INTERIM CHANGE REQUEST

Plan Title/Rev. Unit 1 ISI Plan Rev 3 ICR No. FSI-IR3-003

INTERIM CHANGE REQUEST

Plan Title/Rev. Unit 1 ISI Plan / Rev 3. ICR No. 151-1R3-04

ILLUSTRATIVE USE ONLY THIS DIAGRAM DEVELOPED FROM FLOW DIAGRAM M1-0311 SH A	
TU ELECTRIC CPSES UNIT 1	
INSERVICE INSPECTION BOUNDARY DIAGRAM	
CHILLED WATER SYSTEM SHEET 5 OF 7	
REV 2	APPROVED: <i>Daniel E. [Signature]</i> 3/28/15

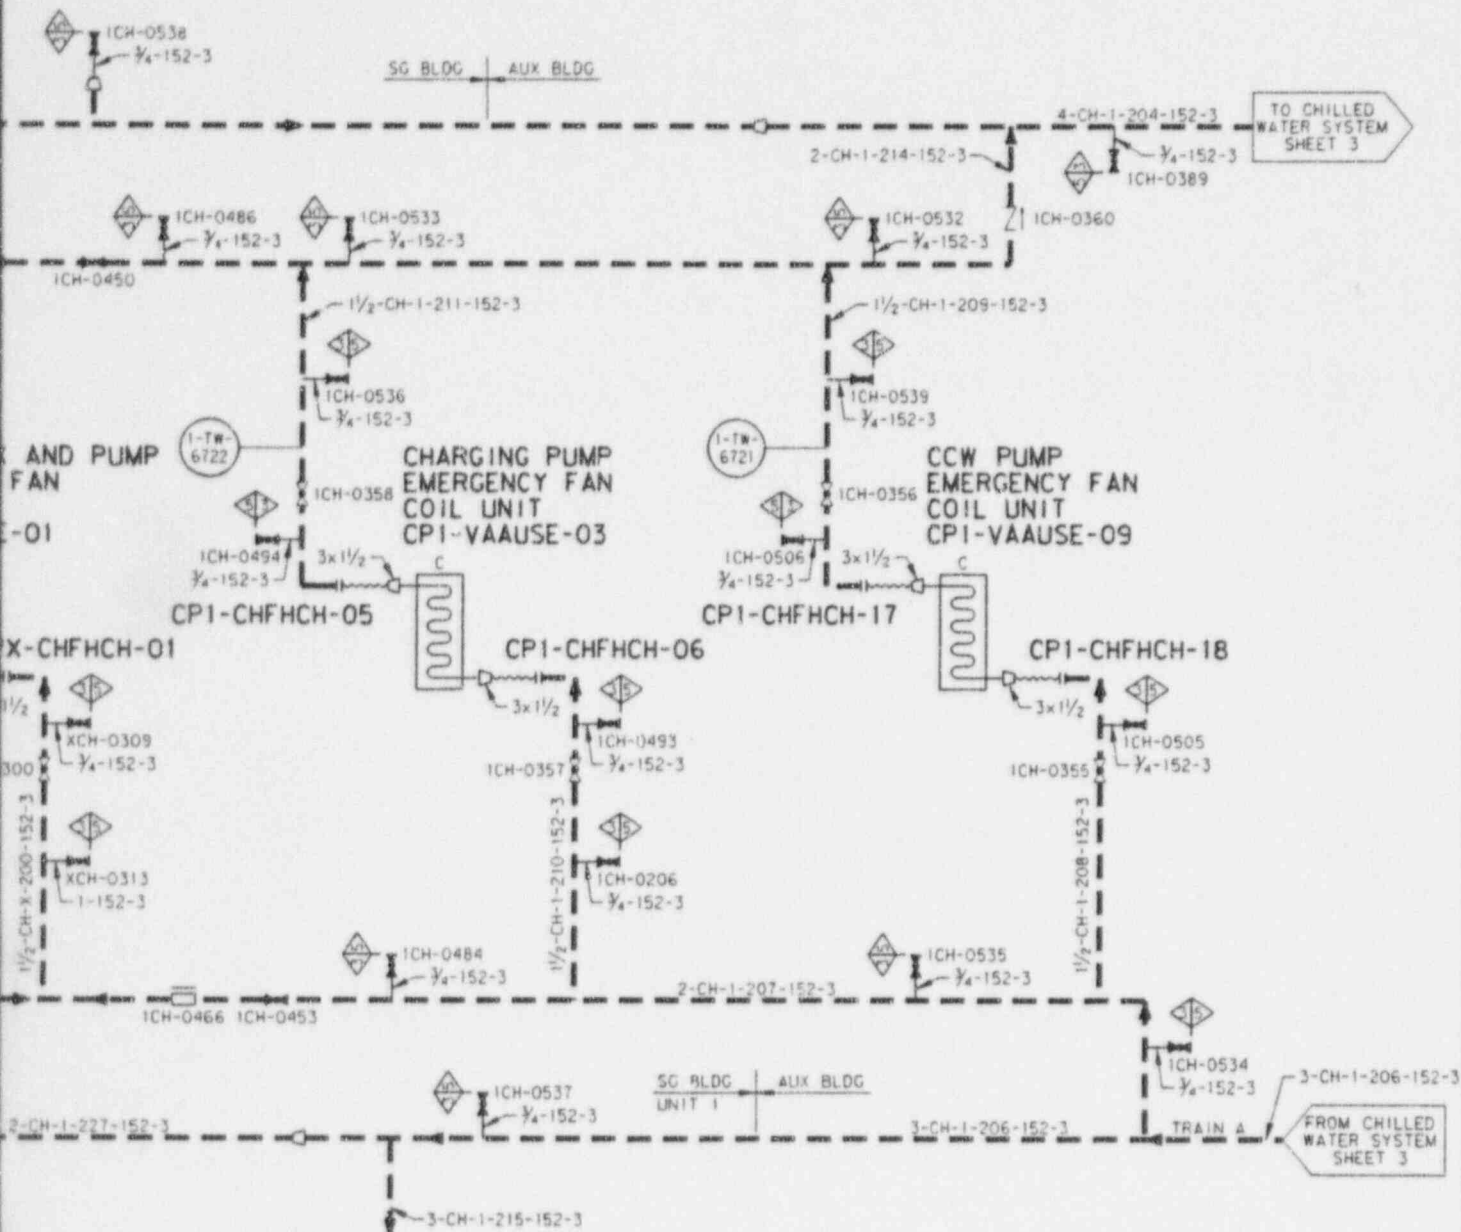
- Correct boundary diagrams to reflect plant configuration
- Incorporate DCN 8945 which is in progress.
- Correct line type on boundary diagrams SI-sh 849 for recirculation piping from containment sumps.

- Revise the following drawings from Rev 1 to Rev. 2 in Section 2.0
 - CH - Sh. 586 CT - Sh. 182
 - RH - Sh. 2 SI - Sh 849
- Revise drawing RH-sh 1 from Rev. 0 to Rev. 1
- Change Pressure Test Line List (section 5.0, Table 9) to reflect these changes.
